Re: Supplemental Submission No. 4 for Rezoning Application Case No. 20983

Stonehaven at Rockingham South (PIDs 00293308, 40433849 and 40433858), off Wentworth Drive & Dunbrack Street, Rockingham South, HRM.

To the Halifax Development and Planning offices,

Please consider the modifications to the Wentworth Drive development proposal for rezoning. The changes are based on various comments from Karen Godwin and Jamy-ellen, as well as an ongoing discussion between KWR (Kevin Riles) and the respective departments.

A-100

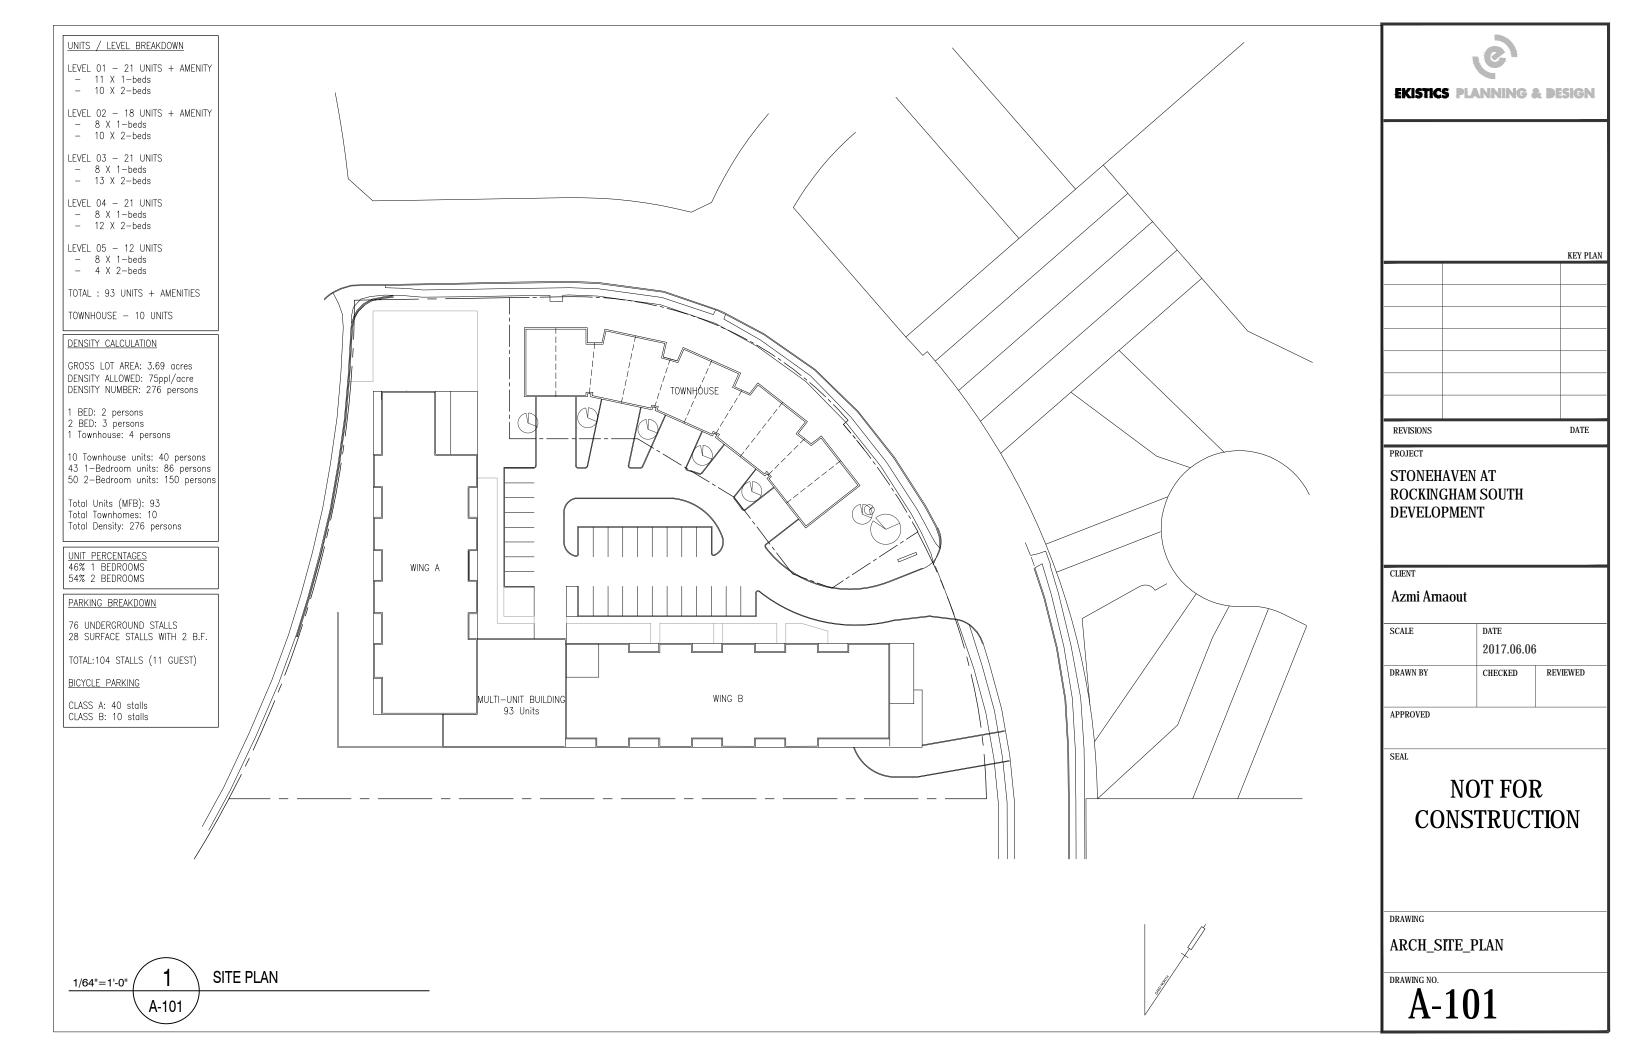
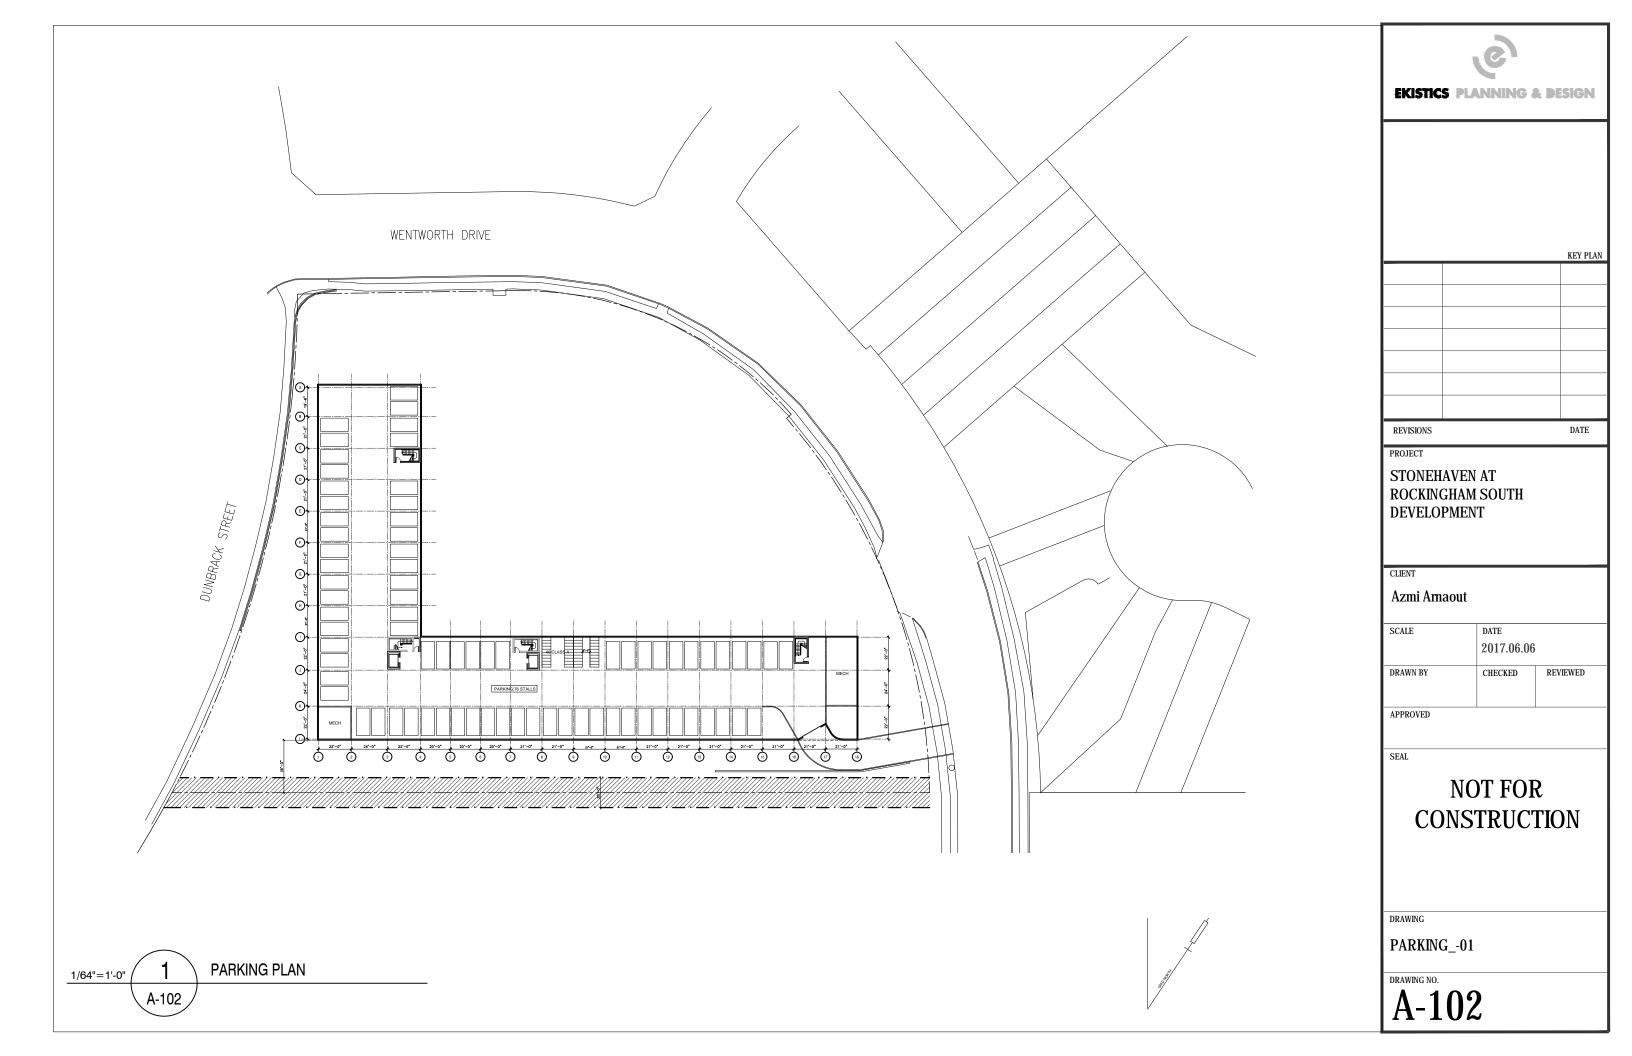
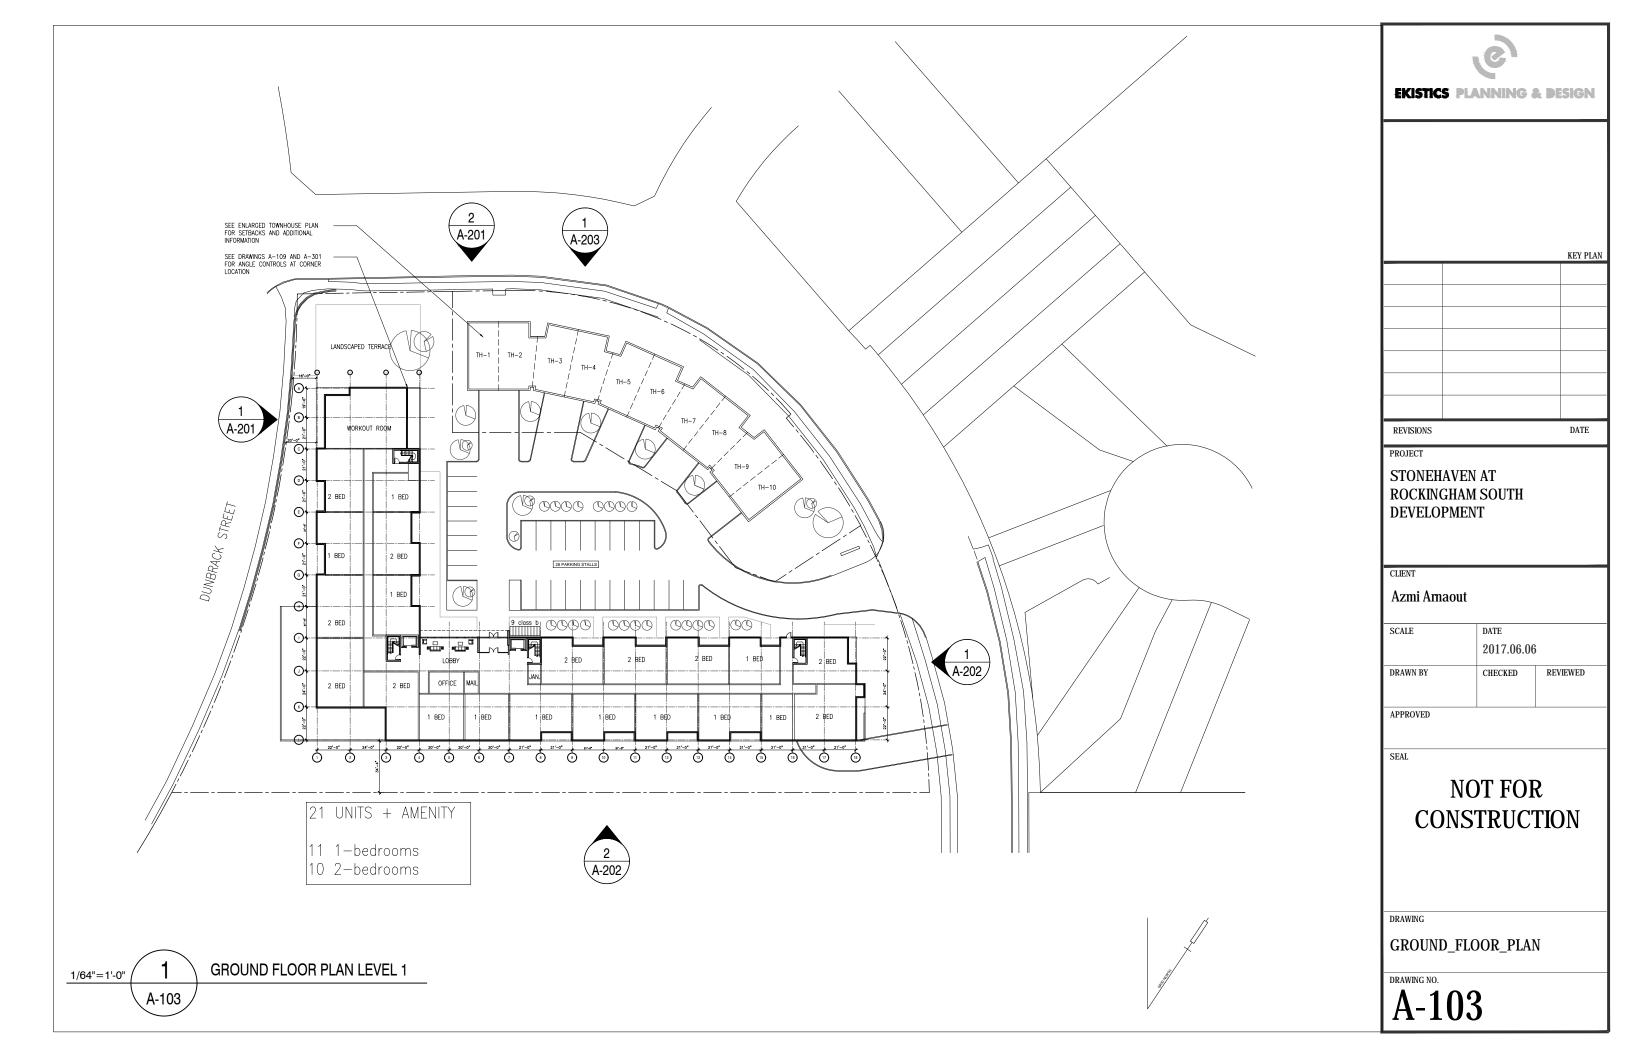
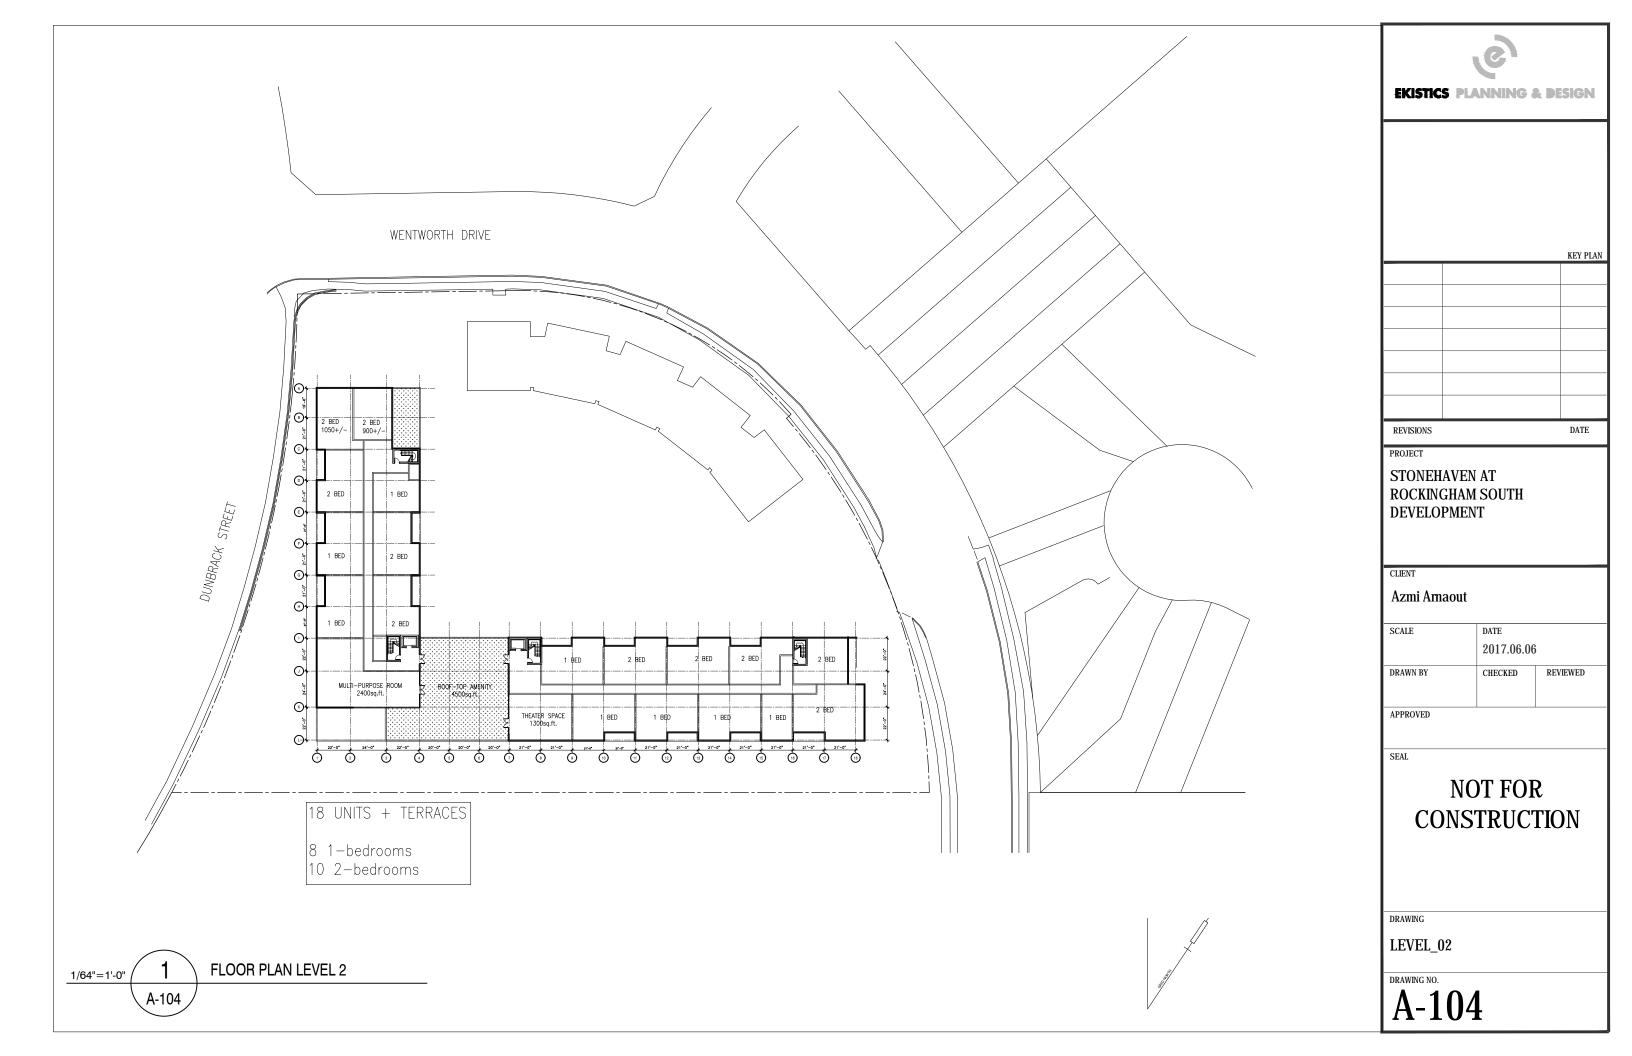
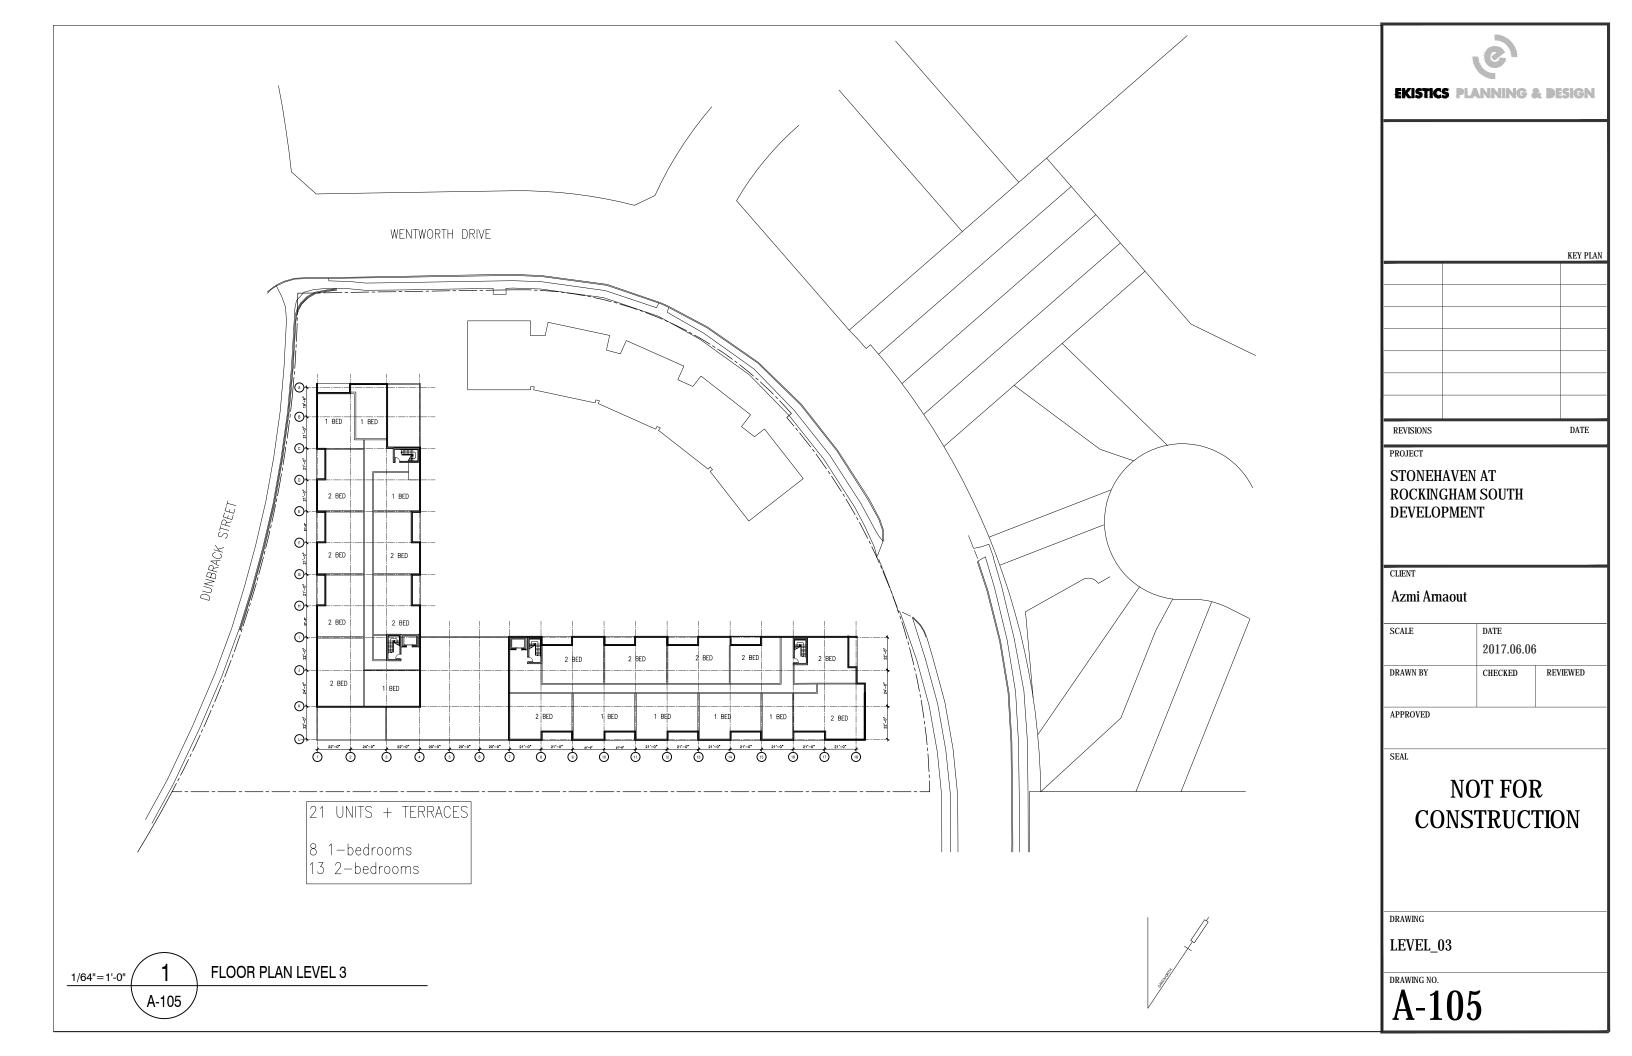
02 Density Calculation: See attached Gross Lot Area drawing A-100 illustrating the 30' extension into the facing streets – in both cases lesser than the center of street. The *Gross Lot Area* is 3.69 acres, for a total density of 277 persons (75 persons / acre). The combined density of the Multi-unit building and the Townhouse is 276 persons for the entire site.
